Re: **Violet Hill Gravel Pit, Town of Mono  
Burnside Review Comments**

We have received the following peer review comments provided by RJ Burnside:

**Re: Greenwood Pit - Town of Mono  
Peer Review – Traffic Study  
Project No.: 300039415.0000**

**Re: Greenwood Pit - Town of Mono  
Peer Review – Municipal Engineering  
Project No.: 300039415.0000**

SCALE: 1:750    JOB NO. 114239  
DRAWN: SBH    DATE: MAR/17    DWG. **PLAN 2**

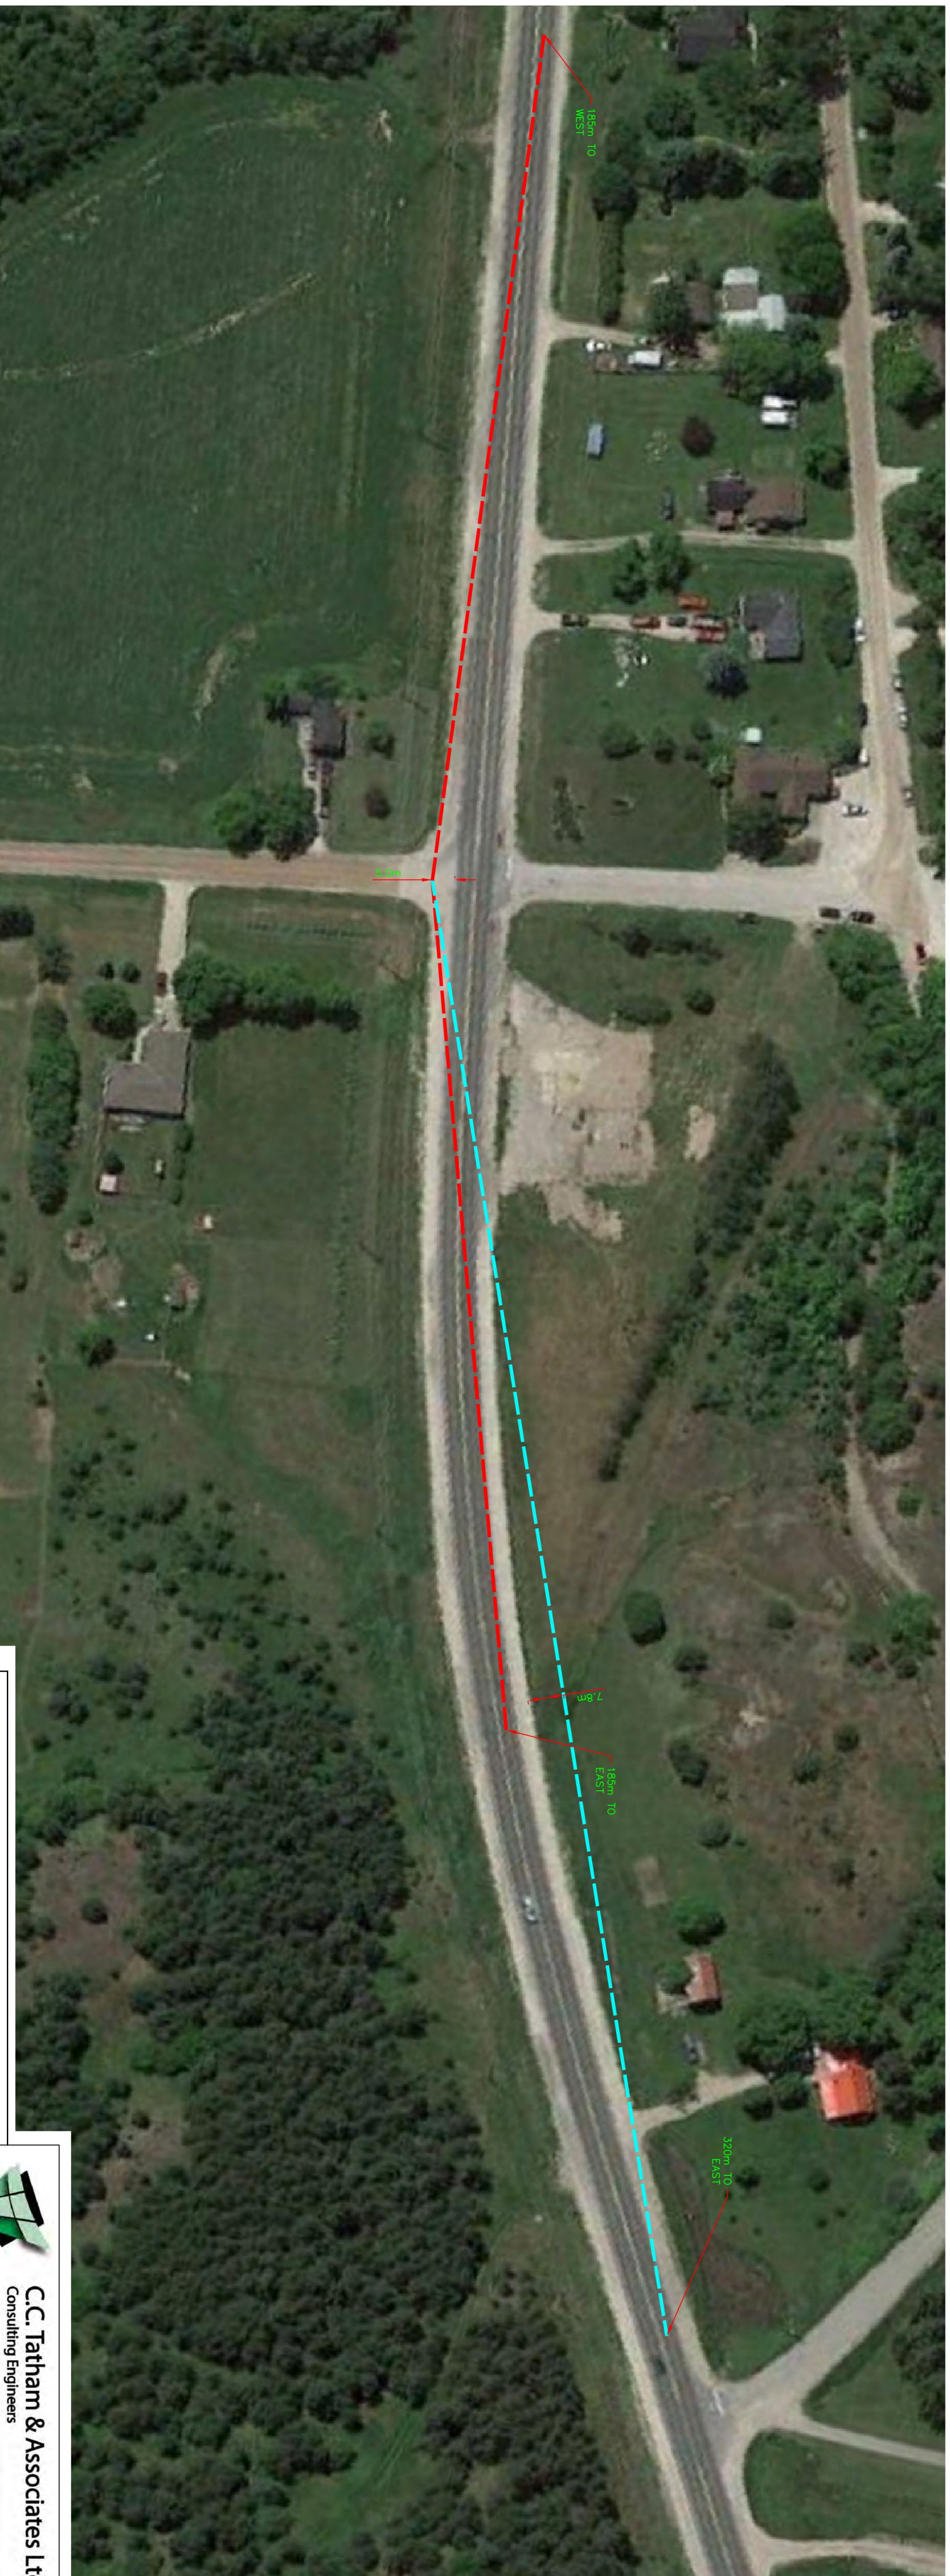
Tatham recommended a westbound left turn on Highway 89 at 3<sup>rd</sup> Line East with an eastbound right turn taper. The improvements were indicated to be shown on Plan 1; however, that plan was not attached. This plan should be provided for review. With provision of the westbound left turn lane, there should also be an eastbound left turn lane provided. We concur with the need to provide the left turn lane and taper. Furthermore, we note that loaded trucks entering Highway 89 from a stopped condition will encounter a lengthy uphill gradient whether they are eastward or westward bound. Residents of the Town will experience delays and a reduced level of service. During the weekday PM peak hour by 2027, there will be a vehicle every 6.5 seconds in the westbound direction and a vehicle every 7.4 seconds in the eastbound direction. Acceleration lanes in both directions should be considered and are recommended for gravel trucks. The design will be subject to Ministry of Transportation of Ontario ("MTO") approval. The operational analysis was not updated to reflect the recommended roadway improvements. An updated operational analysis should be provided for review.

Tatham indicate that they have in excess of 320 m to/from the west, which exceeds the 300 m minimum decision sight distance. They provide photos in Figures 13 a, b, and c that illustrating looking east and having over 320 m sight distance available, but do recommend relocation of a street name sign located to the east of 3<sup>rd</sup> Line East. Details of where they propose to relocate the sign and any potential changes / mitigation measures should be identified.

Plans 1 and 2 appear to have been omitted from the submission; both are attached.

It is noted that the traffic review has been submitted to the MTO, who have provided comments (dated August 14, 2017). While we appreciate the comments from Burnside, MTO has jurisdiction over Highway 89. In their review, MTO noted that they generally agree with the revised access location (along 3<sup>rd</sup> Line East) and the findings of the *Traffic Review*, subject to clarification of design issues for the highway improvements. All improvements to Highway 89 will be completed to the satisfaction of MTO, in accordance with the study recommendations and MTO requirements, which includes the preparation of engineering drawings to provide the requisite design details (eg. turn lanes, corner radii, sign relocation, etc.).

## 2014 COUNT DATA

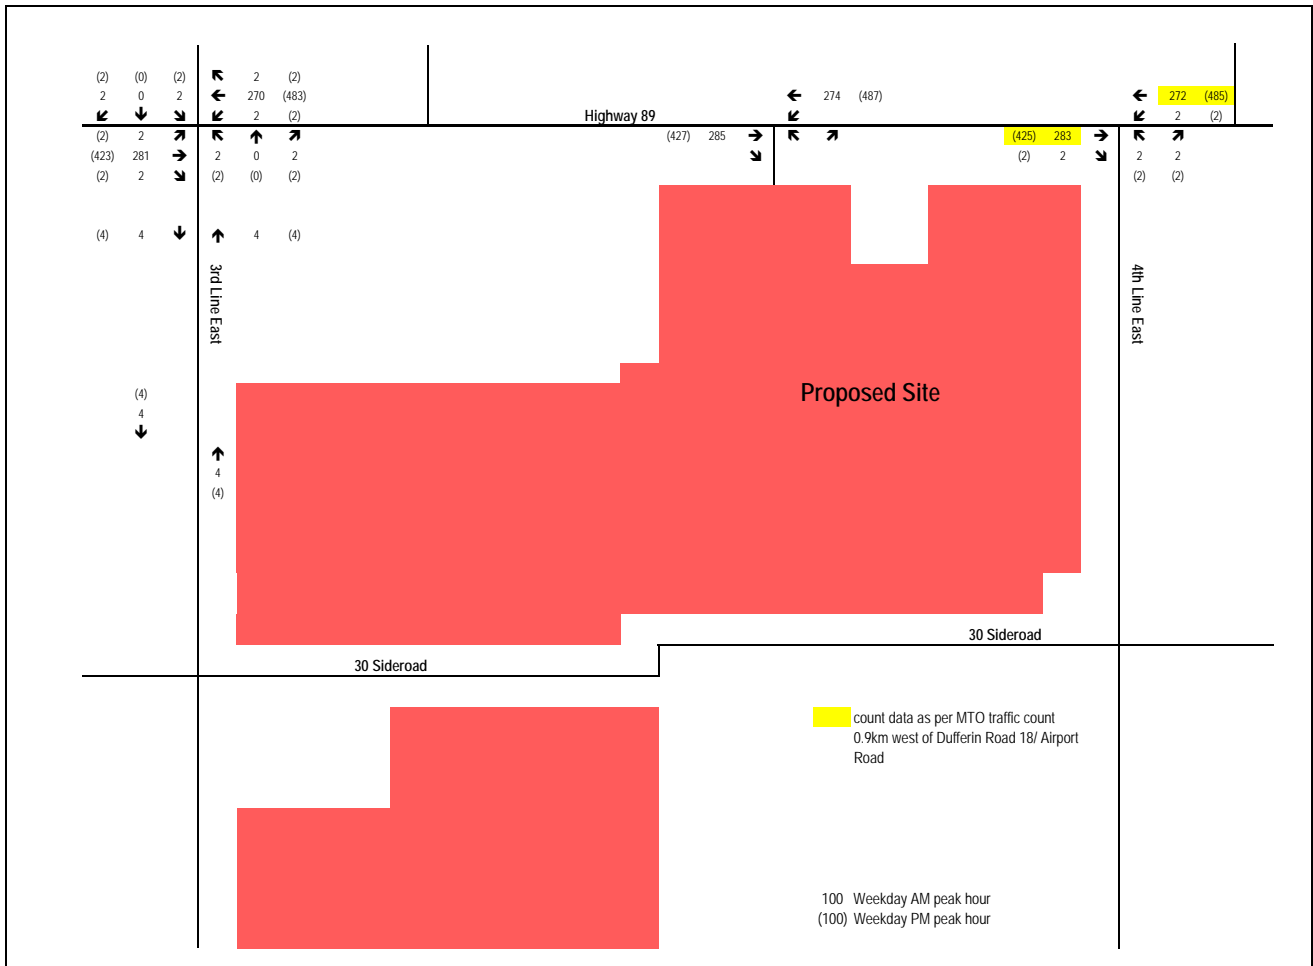
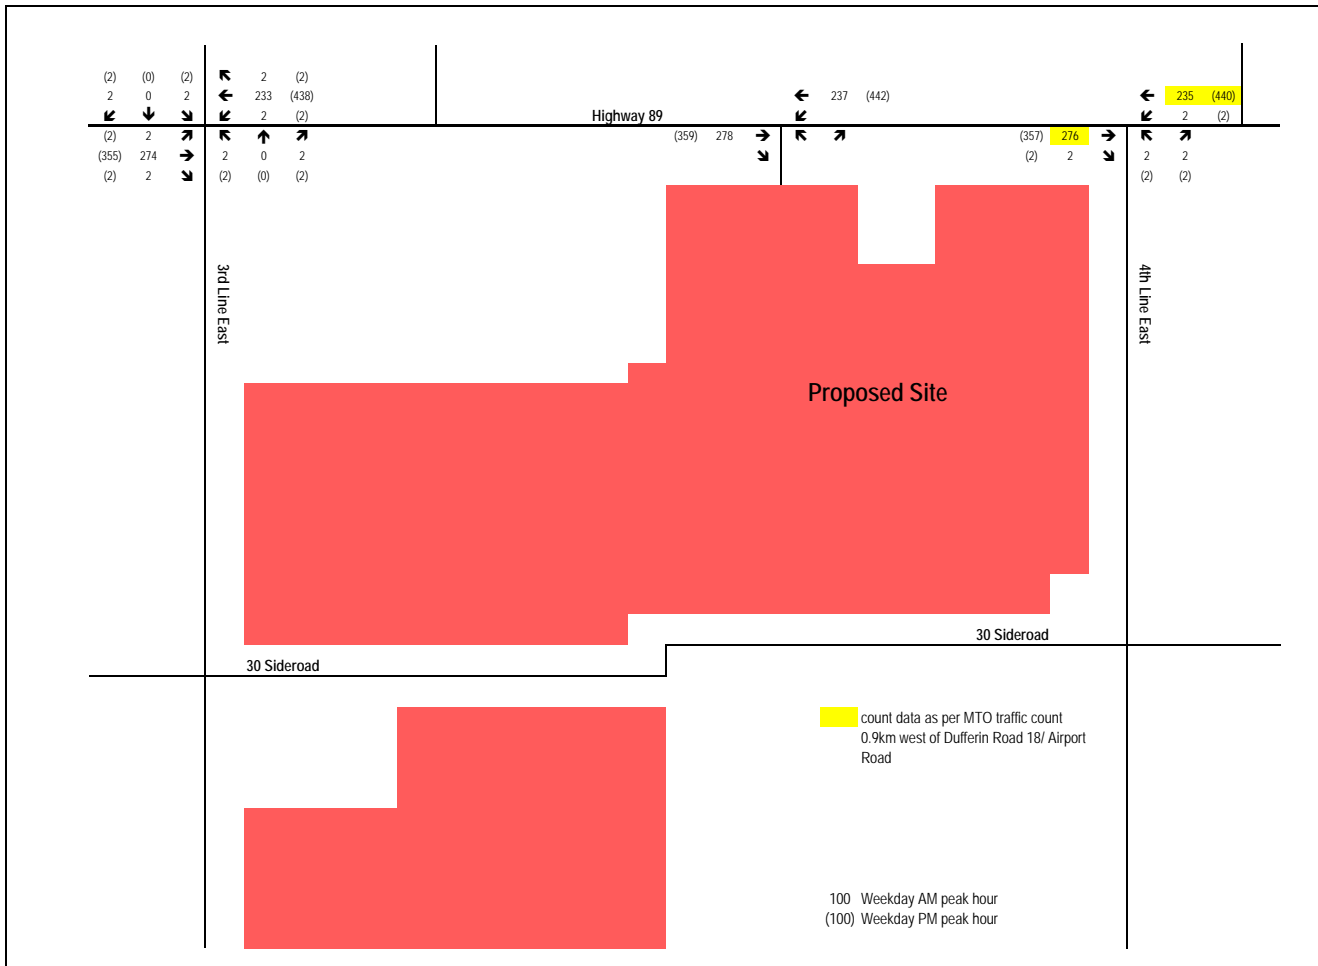
Traffic counts were completed in 2014 and grown by 1% per annum to 2017 traffic conditions. The 2014 traffic data has not been provided and we can not confirm the projections. The consultant should provide the 2014 traffic data. We note that traffic volumes on Highway 89 over the past few years have remained relatively consistent and a 1% growth rate per annum is reasonable. It is not clear how the traffic volumes on Highway 89 were developed, but it appears that they are within the range of traffic counts provided in the 2015 study. A current traffic count should have been undertaken at the study intersection as a traffic count was not completed at the 3<sup>rd</sup> Line East / Highway 89 intersection. Traffic volumes on 3<sup>rd</sup> Line East were estimated.

Traffic volumes on Highway 89 were established from the August 2014 peak hour volumes recorded by MTO 0.9 km west of Dufferin Road 18 (in that they were reflected the greatest volumes, higher than those recorded at the noted intersections). The respective count data is provided in Appendix A.

**FIGURE 1**

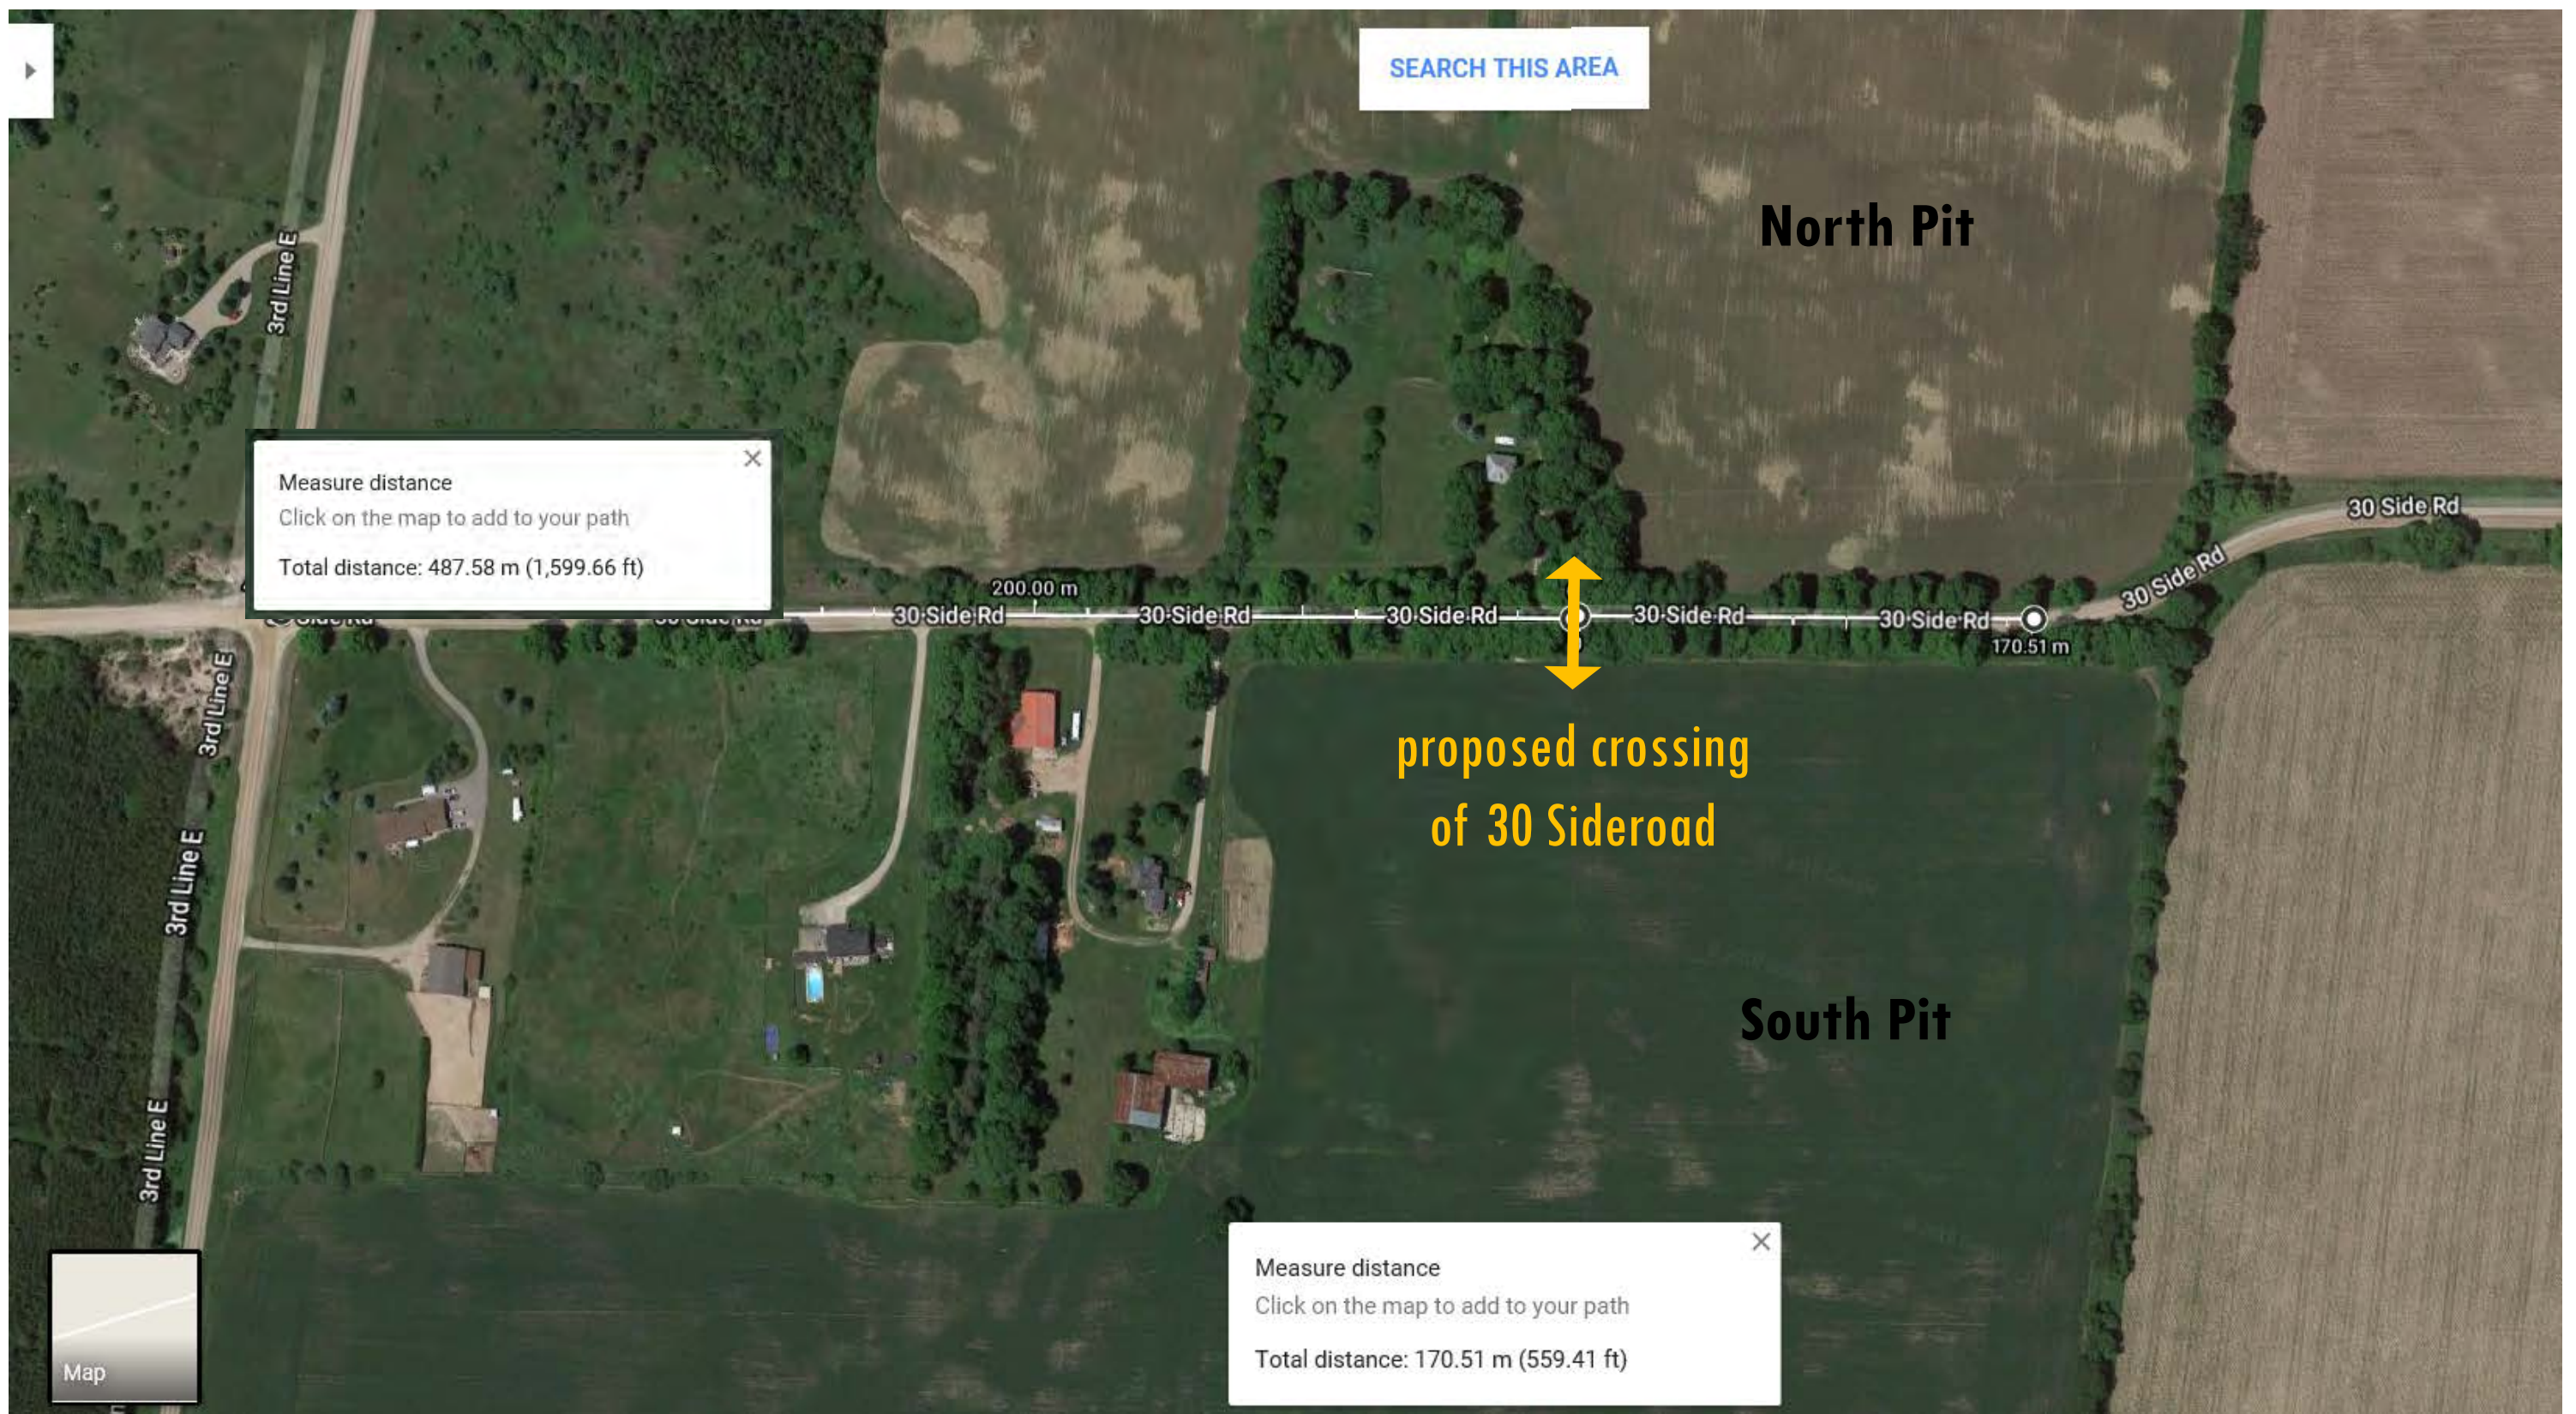
The pit is located on 30 Side Road. No details have been provided on driveway locations to 30 Side Road or the volume of pit crossing traffic or aggregate handling. The only reference provided on the Operations plan is "Material movement from Operation Areas D and E shall only be through Area A, and the main entrance. Site-to-site access shall be by a controlled crossing of 30 Side Road with gates and stop signs." There is a bend in 30 Side Road east of the limit of the pit property on the south side of 30 Side Road. Prior to obtaining approvals for the pit, the following should be provided with respect to the crossing of 30 Side Road:

- Driveway details
- Estimated traffic using the driveway and type of function
- Review of sightlines and incorporation of any mitigation measures deemed necessary
- Confirmation that the road is structurally adequate or implementation of remediation measures
- Acceptance by the Town of findings, recommendations, designs, securities, and construction

As the pit operations proceed to the south of 30 Sideroad, we understand that crossings of 30 Sideroad will be required, a preliminary plan of which is provided in Appendix C (denoted as Figure 1). The extent of crossings will be a function of the pit operations - as a worse case, the total volumes to be generated by the site could be required to cross 30 Sideroad. As site access will remain via 3<sup>rd</sup> Line, traffic will enter the site, travel through the north pit, cross at 30 Sideroad to the south pit, obtain material, cross at 30 Sideroad for the return trip and exit to 3<sup>rd</sup> Line East. Given the limited volumes on 30 Sideroad, and the provision of stop control on the crossing (in both directions), we do not foresee any operational issues at the proposed crossing location. No access to or from the site via 30 Sideroad will be permitted.

As per Figure C1 (provided in Appendix C), the proposed crossing is located in excess of 170 metres west of the 'S' curve to the east, and 480 metres east of 3<sup>rd</sup> Line East. Given this location, and the relatively straight and flat profile of 30 Sideroad (as evident in Figure C2), acceptable sight lines will be provided in both directions such that approaching motorists can readily observe a crossing truck and react accordingly. For a design speed of 80 km/h, the minimum stopping sight distance (the distance required to see a hazard and bring a vehicle to a stop) is 135 metres.

As with the requirements for 3<sup>rd</sup> Line East, we suggest any associated works/improvements to 30 Sideroad be a condition of approval. We do recommend that the crossing be constructed to include a minimum of 2 lifts of asphalt, 150 mm Granular A and 450 mm Granular B. In addition, the approaches on 30 Sideroad should also be paved a minimum of 20 metres in either direction to provide a means of transition between the existing gravel surface and the proposed paved surface of the crossing.
